## **ADDENDUM NO. 2**

**PROJECT:** **ST. JOHN THE BAPTIST PARISH  
GOVERNMENT COMPLEX**

**Date of Addendum:** **May 12, 2016**

project number 0843	date 5.12.16	drawing number <b>ASK-01</b>
file name Wall Sections		this drawing modifies: A.3.6
issued for Addenda no. 2

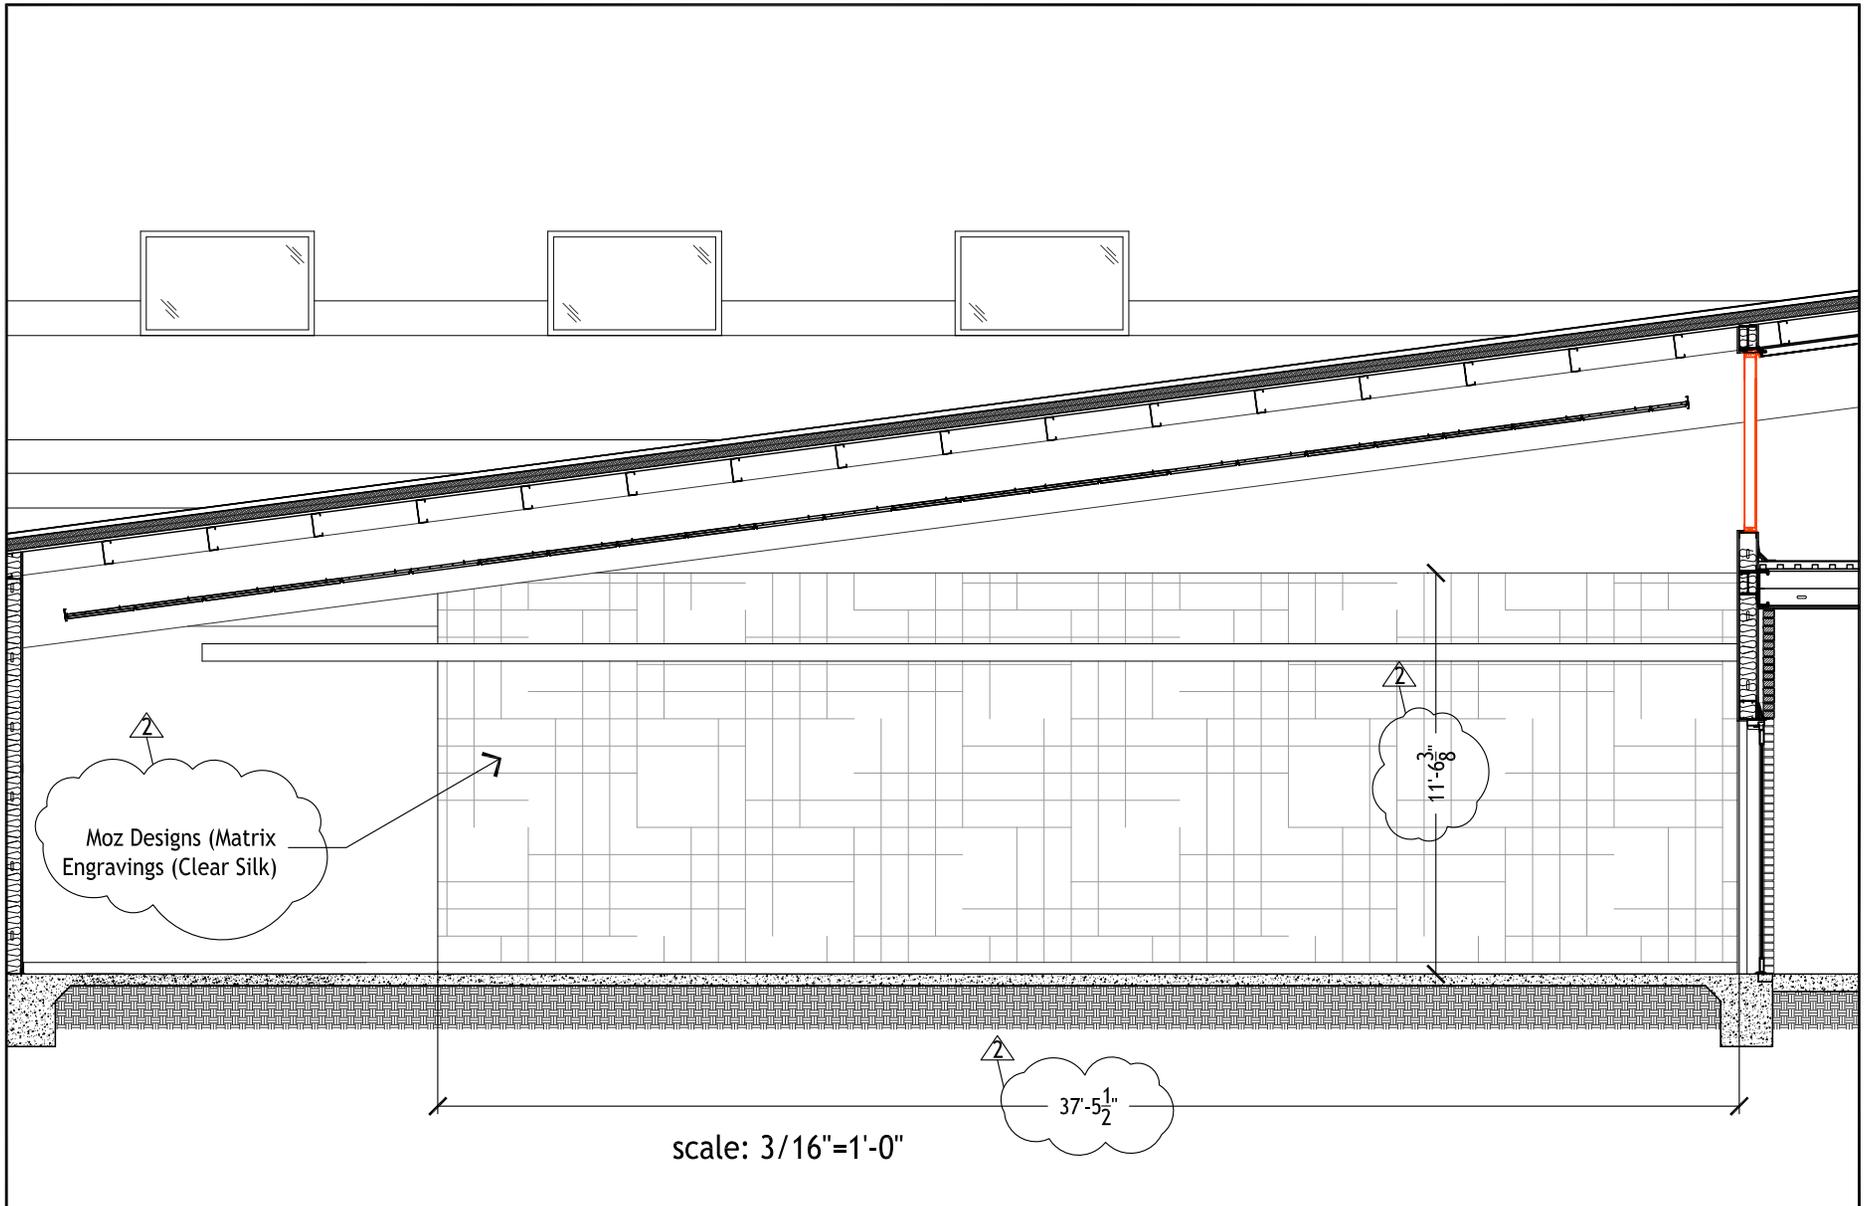
1. Sheets A.2.0, A.2.1 – Remove and replace with the attached.
2. Sheet A.5.0 – Remove note to provide equipment screen. No equipment screens shall be required on roof for this project.
3. See attached ASK-01 detailing material in the Lobby.
4. See attached ASK-02 detailing Registrar of Voters interior elevation.
5. See attached ASK-03 detailing Registrar of Voters interior elevation.
6. See attached ASK-04 detailing elevation of Door 48 at Registrar of Voters.
7. See attached ASK-05 updating floor plan call outs in General Office 103.
8. See attached ASK-06 section of counter at Office 104.
9. See attached ASK-07 section at wet wall in restrooms.

project number 0843	date 5.10.16	drawing number <b>ASK-08</b>
file name A-6/A.3.7		this drawing modifies:
issued for Addenda no. 2		A-6/A.3.7

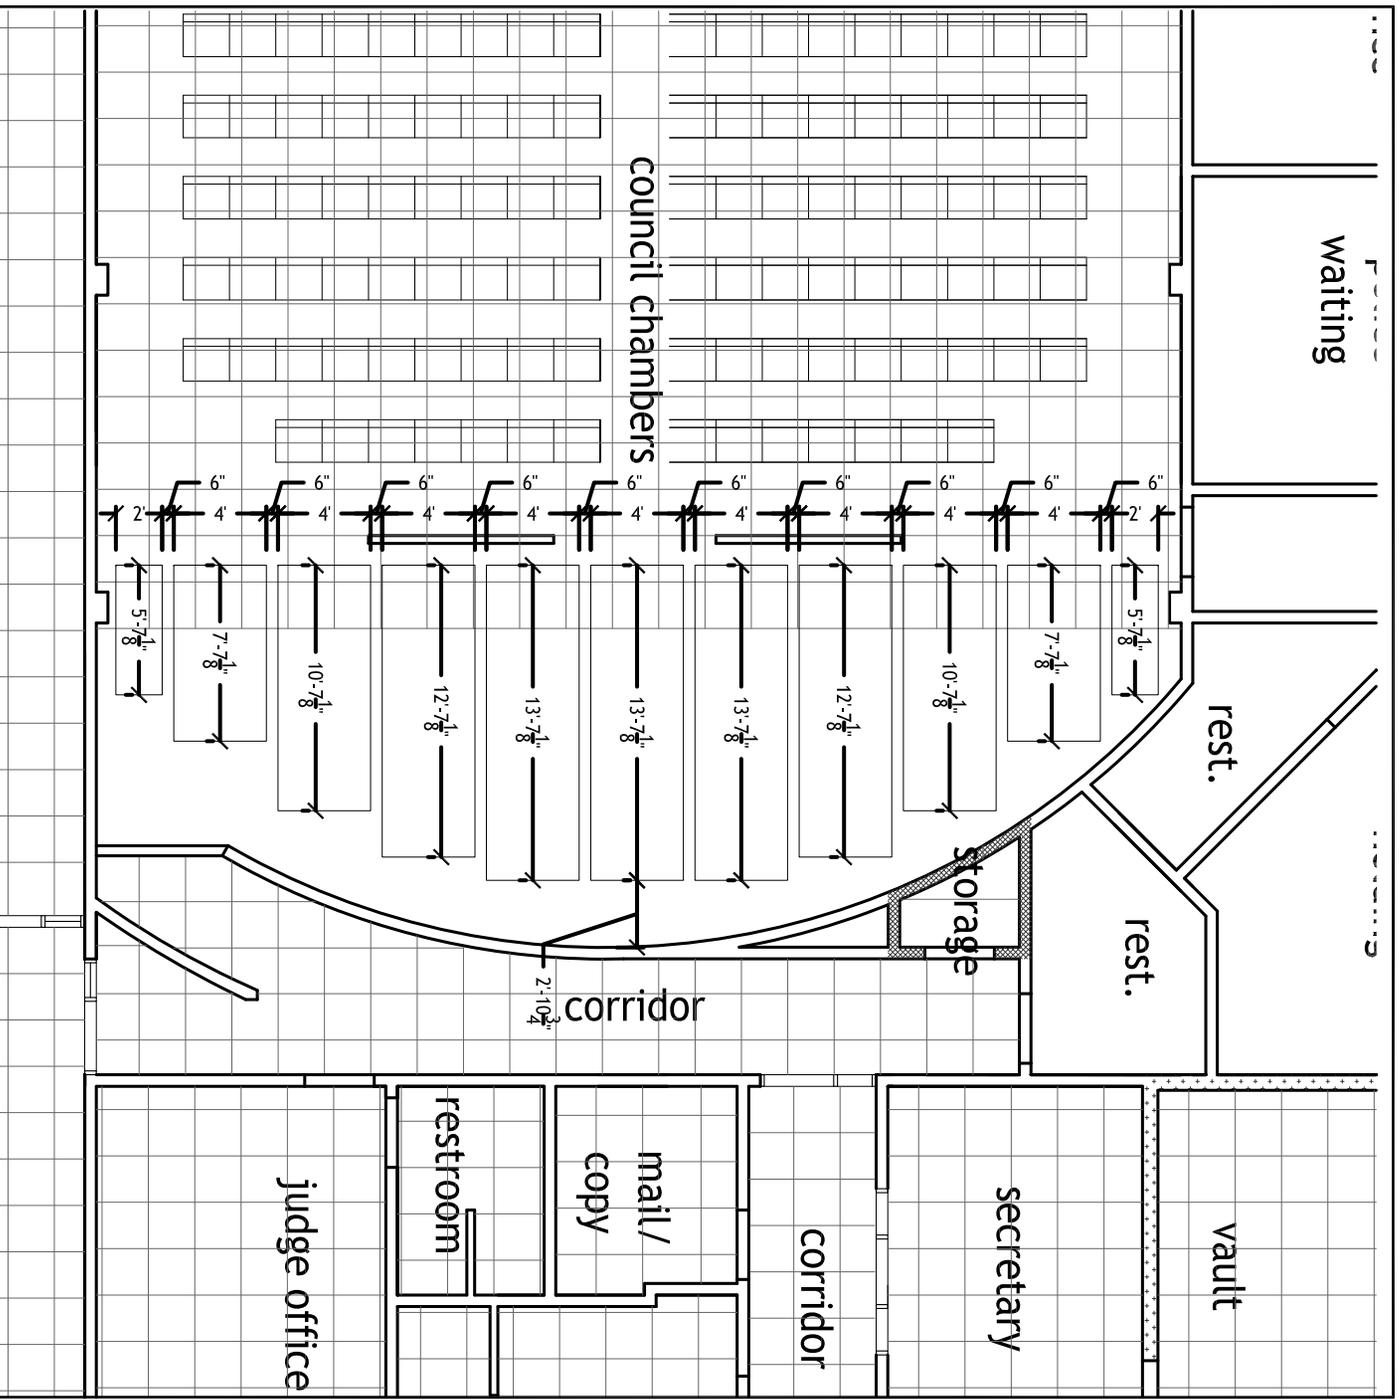
- Question: The Serpentina Waves do not have appropriate sizes and are lacking of any product numbers. We need proper sizing and product numbers for pricing.

Answer: See attached Sketch ASK-08 and ASK-09.
